5 SUB2007-00088

WATSON ADDITION TO LAKESIDE COMMERCIAL SUBDIVISION

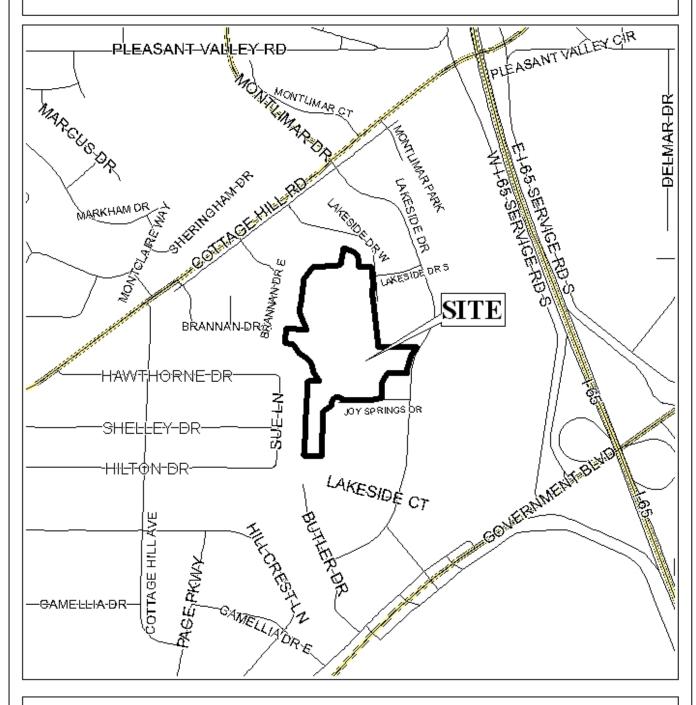
<u>Engineering Comments:</u> Verify detention capacity in lake for proposed development. Any modifications to the lake will require the same confirmation. Must comply with all storm water and flood control ordinances. Any work performed in the right of way will require a right of way permit.

As indicated by the Engineering Comments, the lake – which composes most of Lot 3 – serves as detention for the majority of the Lakeside Commercial Subdivision; and thus, verification of its capacity is a necessity.

- 1) compliance with Engineering Comments (Verify detention capacity in lake for proposed development. Any modifications to the lake will require the same confirmation. Must comply with all storm water and flood control ordinances. Any work performed in the right of way will require a right of way permit);
- 2) placement of a note on the final plat stating that maintenance of the lake/detention facility shall be the responsibility of the property owner(s); and
- 3) placement of a note on the final plat stating that number, size, location and design of curb cuts shall require approval by the Traffic Engineering Department.
